Access Compliance Report

Public Rights-of-Way

(Pedestrian Signals)

Intersection ID: N/A	Main Street:	Cross Street: N/A	Location: N/A
ADA ID: 434D05BBEED5	Signal Type: One Push Button-Non APS	Overall Compliance: No	Severity Score: BTN 1: N/A BTN 2: N/A No BTN: N/A
Codes/Mitigation Info/Possible Solution		Field Measurements/Component Compliance

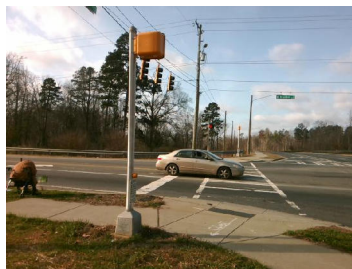
PROW/ADA: TMUTCD 4e.08, R404.2, R404.3, R404.7.2

Possible Solutions: Replace Signal Push Button With APS Button on New Post. Remove & Relocate Sign.
